**LOST CREEK ISR, LLC**

**Re: Response to NRC RAIs Dated July 23, 2015  
UIC Class V Amendment  
Lost Creek ISR Project License SUA-1598, Docket 040-09068**

## RAI-1 – Table 3, Effluent Limits

Injection Well Vault and Piping Schematic

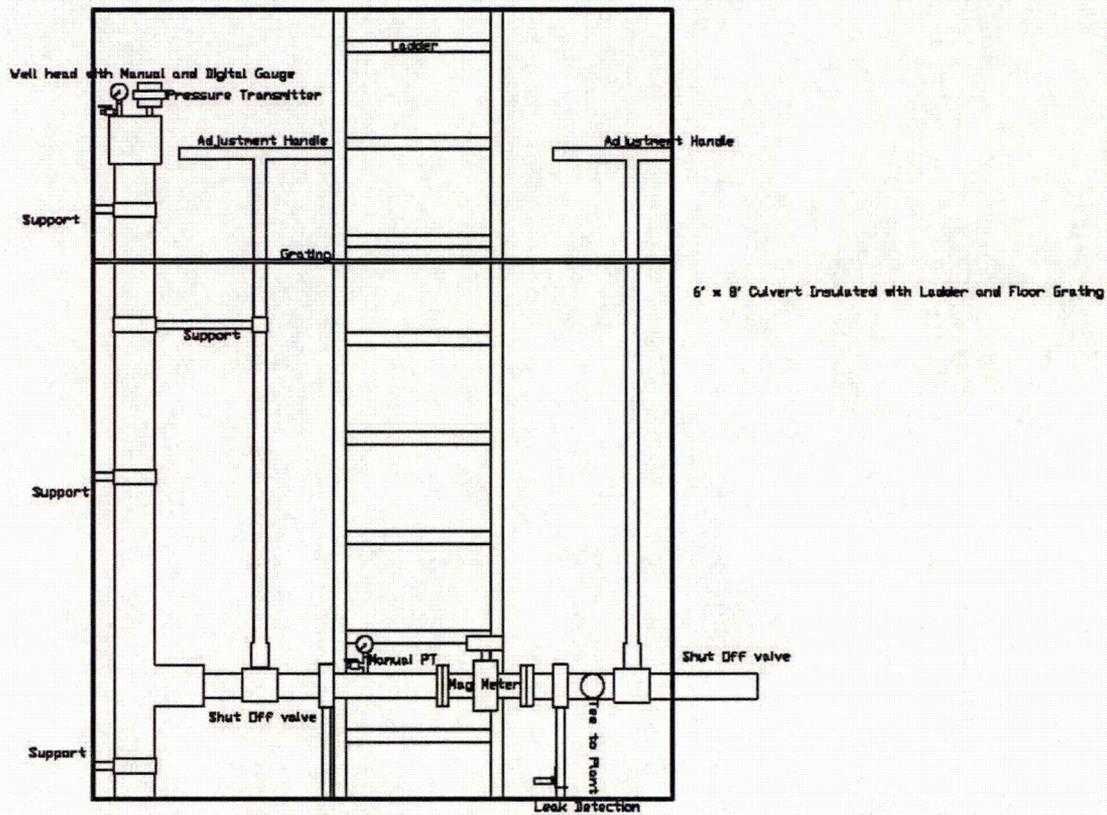
- B) Specific Capacity – Section 2.4 states the specific capacity calculation was approximately 1 gpm per foot of drawdown. If correct, then for injection of 200 gallons per minute at a single well would result in an increase in head at the injection well to ground surface and potential spill at the surface.

### Response:

Every Class V injection well on the Lost Creek property is fitted with a pressure tight, leak proof cap and pressure gauge. Permeate injection wells M-FG6 and M-FG7 will be constructed similarly as shown on the following figure.
